Parent Item Name: Comfort Crew Shoulder Harness

DART SERVICE INSTRUCTION

TO AMEND IIN-D412-702-3 REV. A OR EARLIER

THE PURPOSE OF THIS DSI IS TO CORRECT THE HARDWARE CALLED OUT IN THE D412-702-071 KIT.

FIGURE 2. - DART D412-702-071 LAP BELT INSTALLATION (REF: IIN-D412-702)

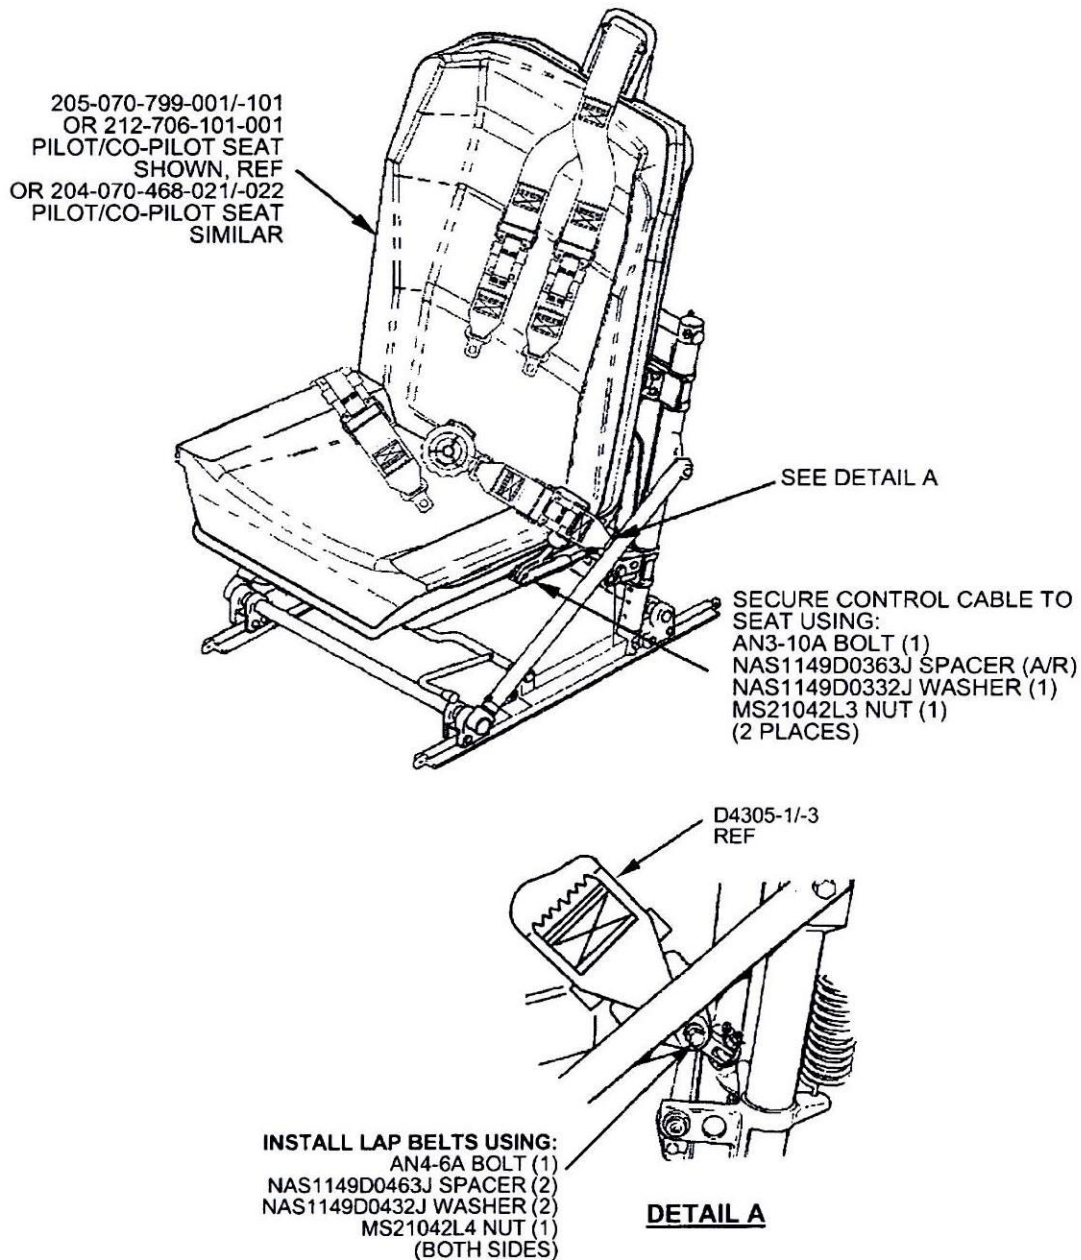
4.0 CHANGES

IS:

QTY -071	P/N	DESCRIPTION
X	D412-702-071	DART PILOT/CO-PILOT SHOULDER HARNESS KIT
1	D4305-041	SHOULDER HARNESS
4	AN3-4A	BOLT
2	AN4-6A	BOLT
2	AN3-10A	BOLT
6	MS21042L3	NUT
2	MS21042L4	NUT
10	NAS1149D0332J	WASHER
6	NAS1149D0363J	WASHER
4	NAS1149D0432J	WASHER
4	NAS1149D0463J	WASHER
